Integrated Designated Development Application No. 523/2014 Dunmore Resource Recovery Redevelopment Lot 1 DP 110135 & Lot 1 DP 419907, 58 Buckleys Road & Lot 21 DP 653009, 44 Buckleys Road, Dunmore

Table 1: Response to comments raised during the public exhibition period

DUNMORE SITE ENTRY LAYOUT PLAN

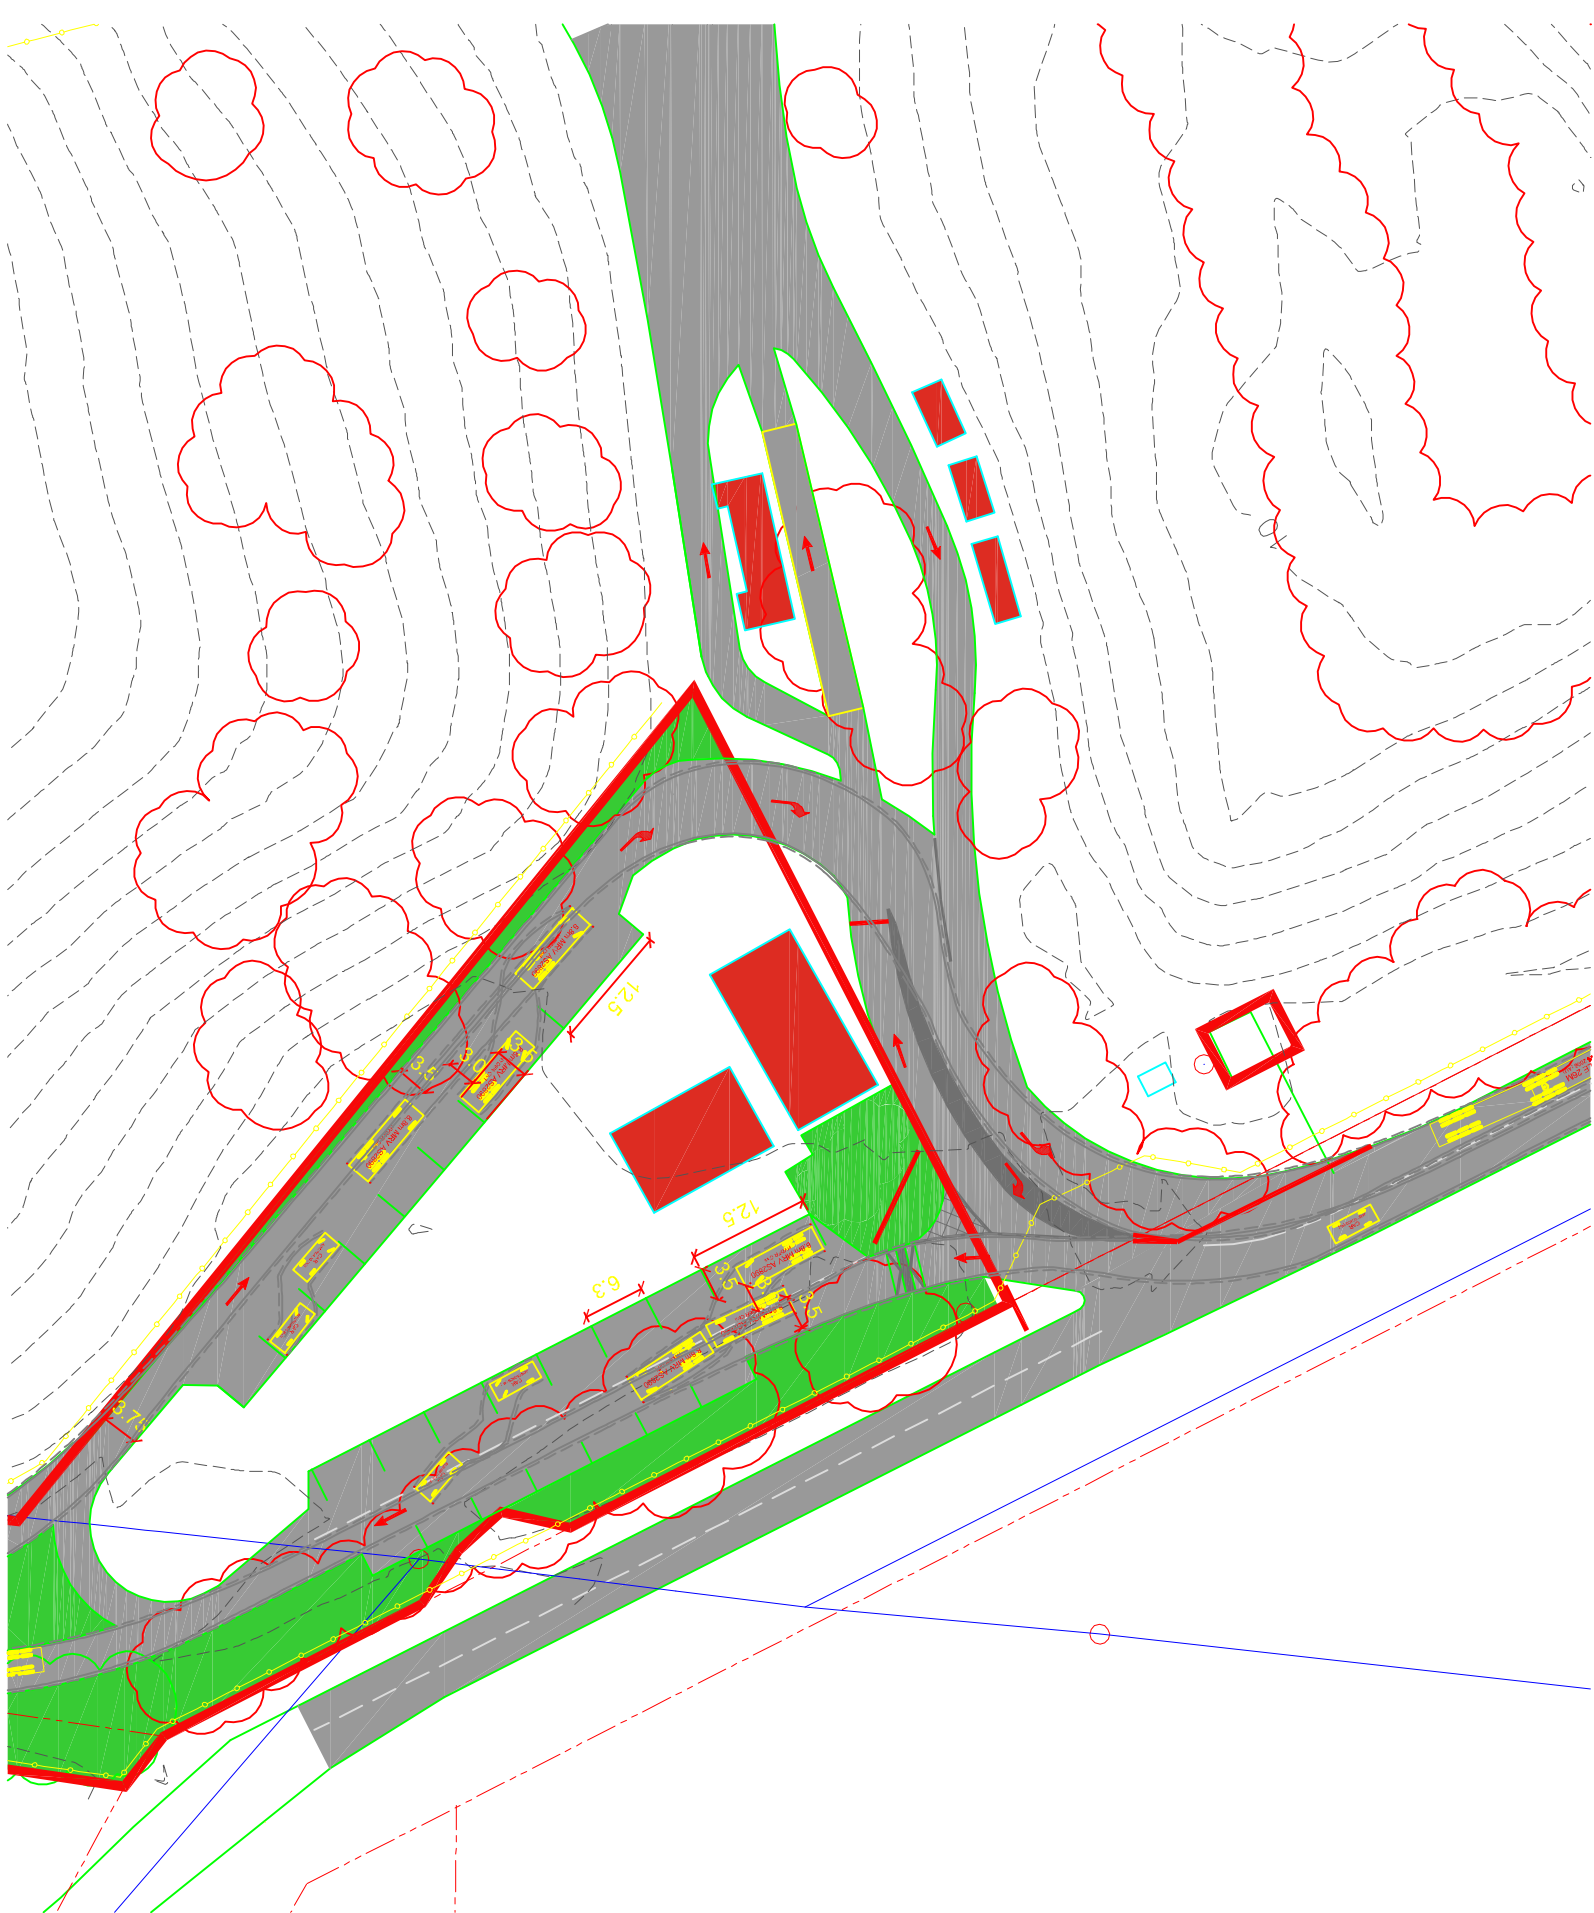
Issue	Comment	Clarification/Response	Reference
Traffic and Parking			
Stop Bars	The EIS p54 figure 5.4 (Volume 1) and site plan show 2 stopping bars. Can you please clarify what is meant by a stop 'bar'. Should these stop bars function as a stop line please clarify which traffic has right of way.	A "stop bar" as defined in the Manual on Uniform Traffic Control Devices (MUTCD) is essentially a stop line. The proposed traffic arrangement prompts incoming vehicles to stop before crossing the path of the existing retail traffic. Traffic signage will be installed to reinforce the right-of-way protocols and safe movement of traffic within the DRWDD site. Section 5.3.1 of the EIS notes that the proposed traffic arrangement prompts incoming heavy (commercial) vehicle traffic on route to the landfill or sandmining operations on DRWDD site to stop before crossing the path of existing retail traffic (departing the resource recovery operations). Exiting retail traffic will have priority over exiting heavy vehicle traffic. On further consideration, a stop line on the exit lane for the retail traffic is not required as heavy vehicle traffic will be required to yield for existing retail traffic. Figure 5-4 in the EIS has been updated to reflect this change and is provided in Appendix D.	Volume 1 of the EIS, Section 5.3.1, Figure 5.4, page 54. Appendix D of this letter

What is the purpose of the 'heavy vehicle queuing/stacking' as shown on the plan? Is it likely that the queuing of heavy vehicles may obstruct entry of vehicles into the site wanting to go to the waste facilities past the Revolve Centre?	The length of the entry lane is approximately 35 m and can accommodate 2-3 heavy vehicles in queue (within the site) at any one time. As discussed above, priority is given to retail vehicles exiting with heavy vehicles entering having to wait until it is clear to cross. Section 8.4.2 of the EIS notes that the peak arrival of heavy vehicle traffic associated with the Proposal is estimated to be a maximum of 6 peak hour heavy vehicle movements (i.e. 1 vehicle per 10 minutes). Hence, it is not expected that queueing of heavy vehicles will obstruct Buckleys Road or entry of heavy/light vehicles turning left into the DRWDD site (travelling to the resource recovery operations).	Volume 1 of the EIS, Section 5.3.1, Figure 5.4, page 54 and Section 8.4.2, page 127
